REQUEST FOR INFORMATION	DATE: February 23, 2017	NO.: RFI-459
--------------------------------	--------------------------------	---------------------

Project Name:	15051-Webster University Interdisciplinary Science Building	Project No.: 15051
---------------	---	--------------------

Subject: RFI#252 Follow up

C400

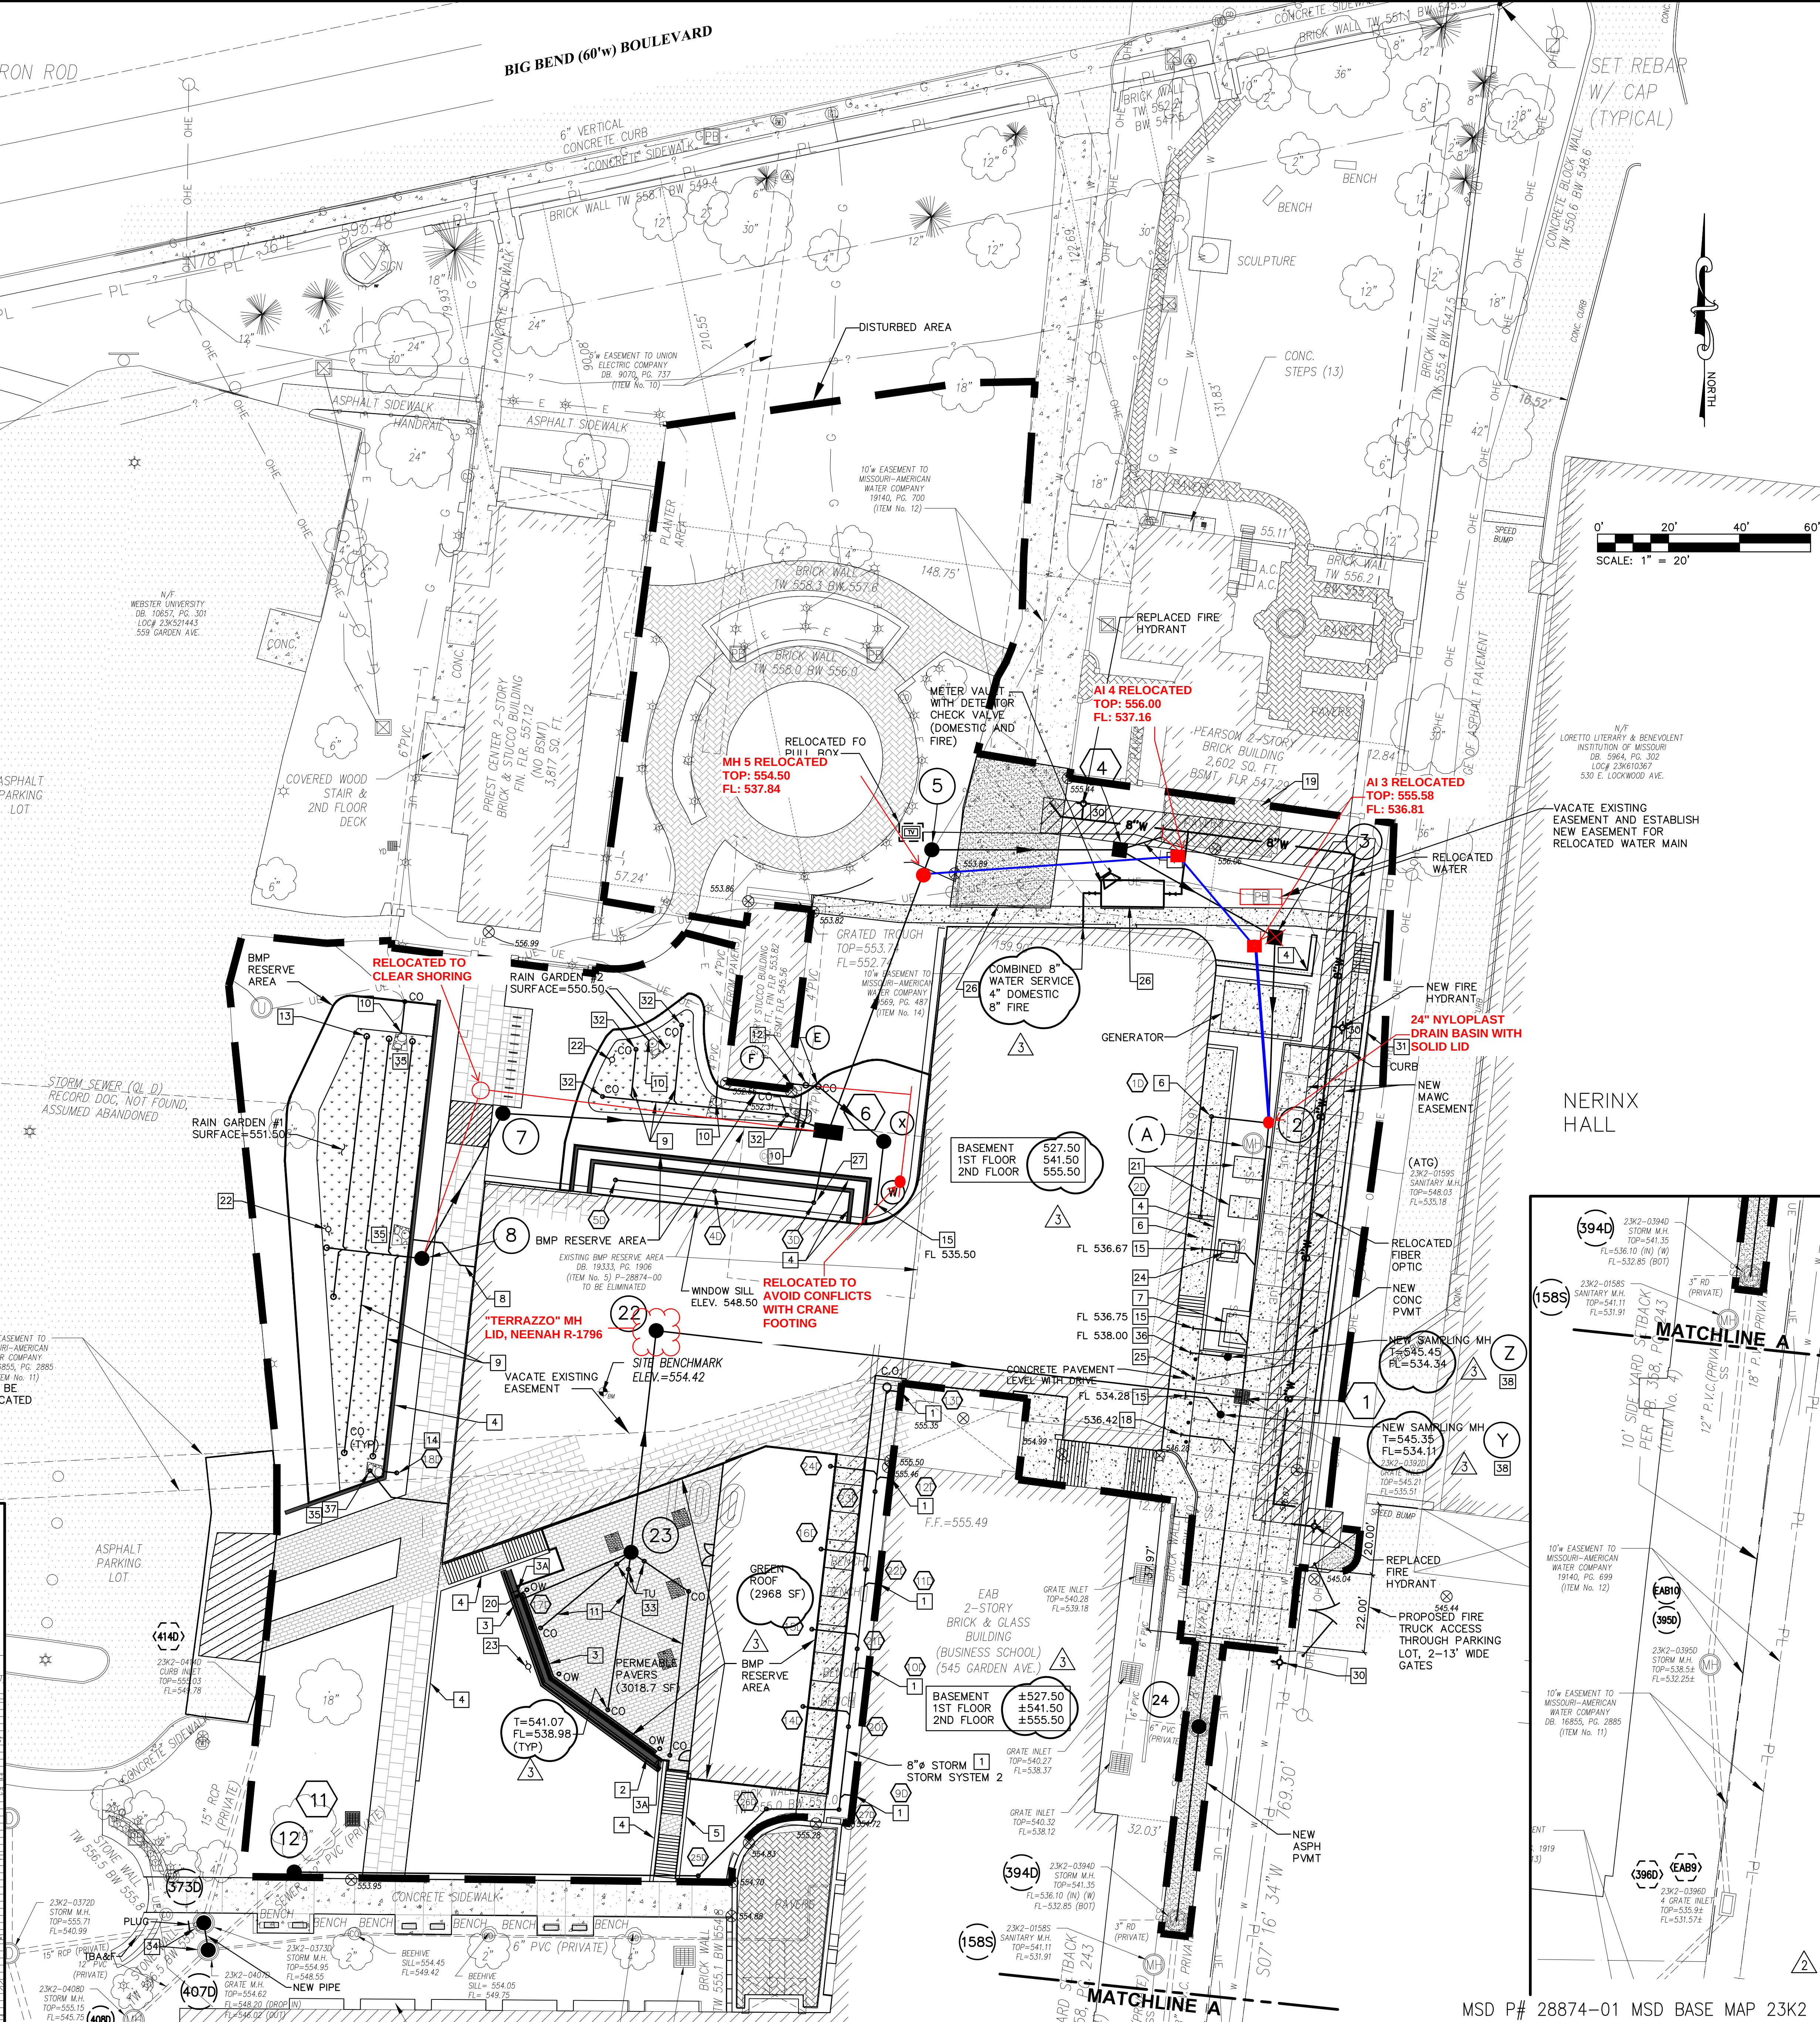
After confirming the extents and depths of utilities with the potholing work completed, we believe that tunneling the electrical manhole as proposed in RFI#252 may not be most viable option for the storm install. This is largely due to the manhole excavation being backfilled entirely with clean rock, not allowing us to safely tunnel under the structure without risk of differential settlement. This, coupled with uncertain subgrade conditions has us concerned about digging that deep of trench along the full south side of the Pearsons building without causing damage to the structure.

After some discussion, we believe there is a route to get the sewer installed, still having to tunnel the duct bank, but that could limit our exposure to settlement damage up against the Pearsons building. See attached plan for proposed routing - Please advise if this is acceptable.

1. See response by Chris Betts, MSD reviewer.

Listed below are my 9-2-16 responses to the same questions asked of MSD on 8-25-16 and 9-2-16. The only new comment that I have is that the new location of AI4 appears to be relatively close to the new water service. You should probably keep them about 10 feet apart.

The proposed revision to PUMI reach #5 to #6 is acceptable. Maintain a 1% minimum slope as shown on the approved plans. This information shall be shown on the as-built drawings.

The proposed revision to PUMI reach #6 to #7 is acceptable. It should be noted that a portion of this reach will be located directly under Rain Garden #2. You should revise the profile to ensure that rain garden bottom will not be in conflict with the proposed 18" PVC storm sewer. This information shall be shown on the as-built drawings.

The proposed revision to PUMI reach #7 to #8 is acceptable. This information shall be shown on the as-built drawings.

Since reaches #2 to #3, #3 to #4, and #4 to #5 are private, MSD has no objection to the proposed revisions. This information shall be shown on the as-built drawings.

Since reaches W to X, X to E are private, MSD has no objection to the proposed revisions. This information shall be shown on the as-built drawings.

Since structure #2 is private, MSD has no objection to the proposed revisions. This information shall be shown on the as-built drawings.
